# PENRITH CITY COUNCIL

## MAJOR ASSESSMENT REPORT

<b>Application number:</b>	DA18/0429
<b>Proposed development:</b>	Torrens Title Subdivision x 2 Lots
<b>Property address:</b>	60 - 64 Bonner Road, AGNES BANKS NSW 2753
<b>Property description:</b>	Lot B DP 38896
<b>Date received:</b>	30 April 2018
<b>Assessing officer</b>	James Heathcote
<b>Zoning:</b>	E4 Environmental Living - LEP 2010
<b>Class of building:</b>	N/A
<b>Recommendations:</b>	Approve

Client: SUSAN KING  
Project: PLAN OF DETAIL SURVEY OVER  
LOT B IN DP 38896  
No.60 BONNER ROAD, AGNES BANKS  
LJMc

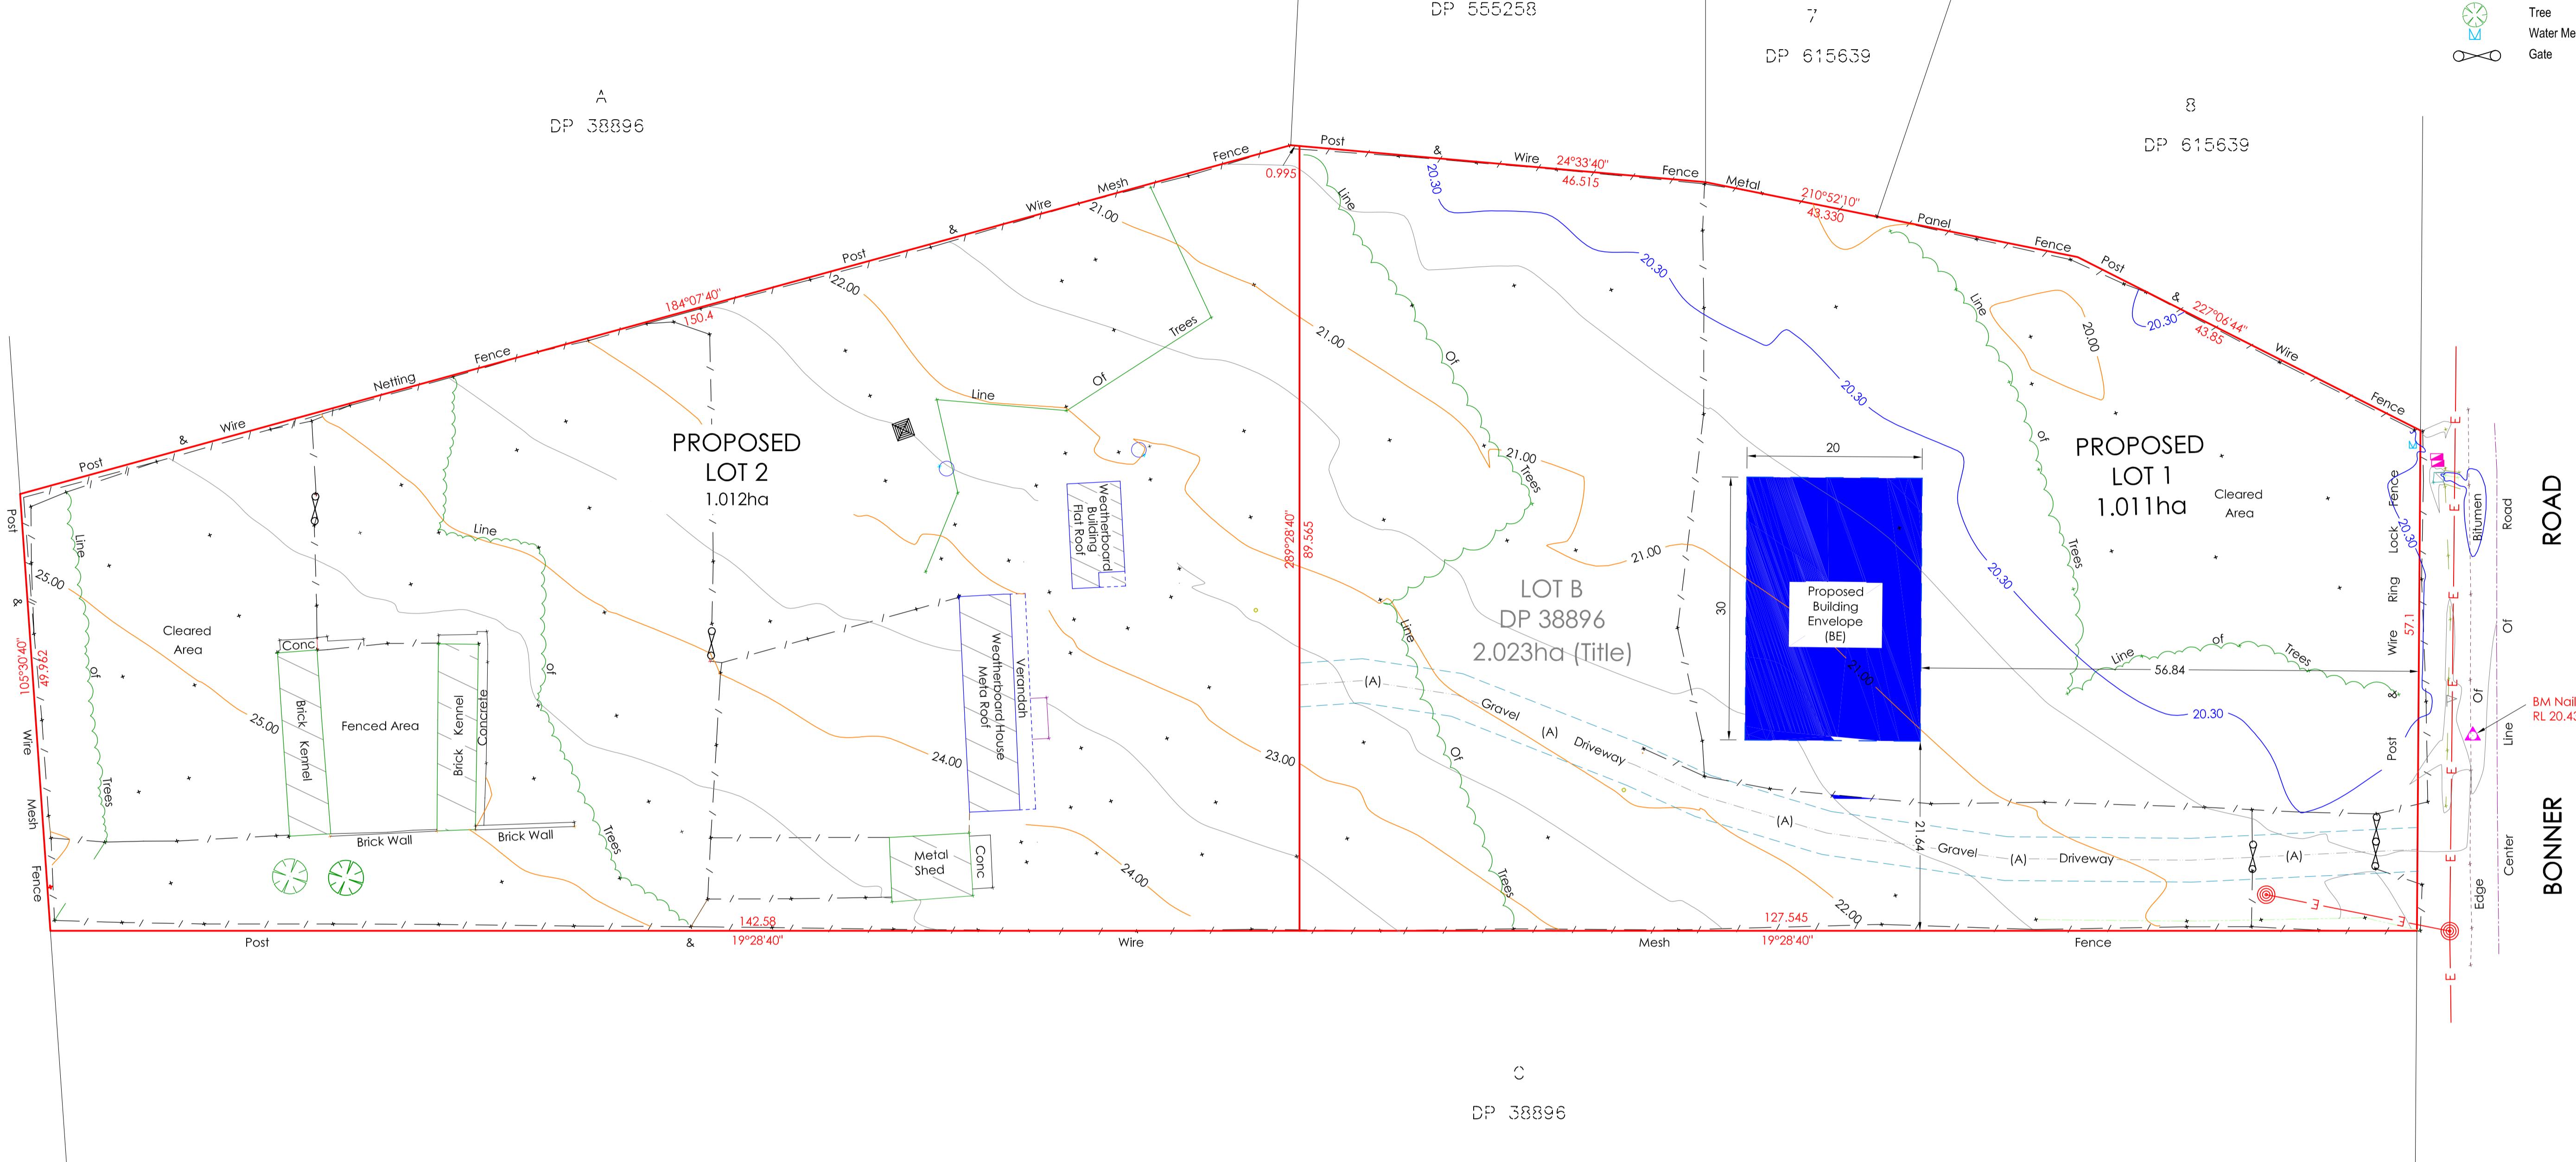
The original survey plan for the proposed subdivision included a battle-axe access handle that ran along the eastern boundary. The result of this proposed handle, including the proposed building envelope for proposed lot 1 meant that 30 trees were identified for removal, as stated in the submitted Flora and Fauna report. In response to the removal, the report proposed 10 trees be planted to replace the loss of vegetation.

The site is mapped as containing River Flat Eucalypt Forest and Cumberland Plain Woodland. Although the site has been cleared in the past, it now supports semi-mature eucalyptus trees. This vegetation is considered valuable and the removal of 30 x trees and re-planting of 10 x trees does not adequately account for the loss of vegetation across the site.

Council raised concern with the applicant regarding the above concerns, and that better retention of vegetation across the site was to be achieved if the proposal is to be supportable.

Referral to Council's Development Engineering team found that the subject site is flood affected by local overland flows with a top water / flood level of RL 20.3m AHD. The survey plan submitted by the applicant displays the location of the area affected by the overland flood flows which is clear of the access way and proposed building envelope. As a result, flood free access is available to both new lots and any site drainage from the future building is able to be drained on site through a level spreader type system. Council's engineers raised no objections with respect to flooding and drainage from the site.

Description	Plan No.	Revision	Prepared By	Date
Plan of Detail Survey Over Lot B in DP 38896 No.60 Bonner Road, Agnes Banks	Sheet 1 of 1	04	Freeburn Surveying	04/08/2017

An amended survey plan was submitted by the applicant that proposed a right of carriageway, instead of an access handle, which is to be placed over the existing driveway that leads to the approved dual occupancy. This amended access way meant that all vegetation along the eastern boundary (15 trees) can now be retained as part of the proposal. An amended flora and fauna report has been further submitted that details a better outcome of the small number of trees being removed for the proposed building envelope and replaced by further planting across the site. Furthermore, as the site is bushfire prone land, impacts of the Bushfire APZs on the existing vegetation has been taken into account.
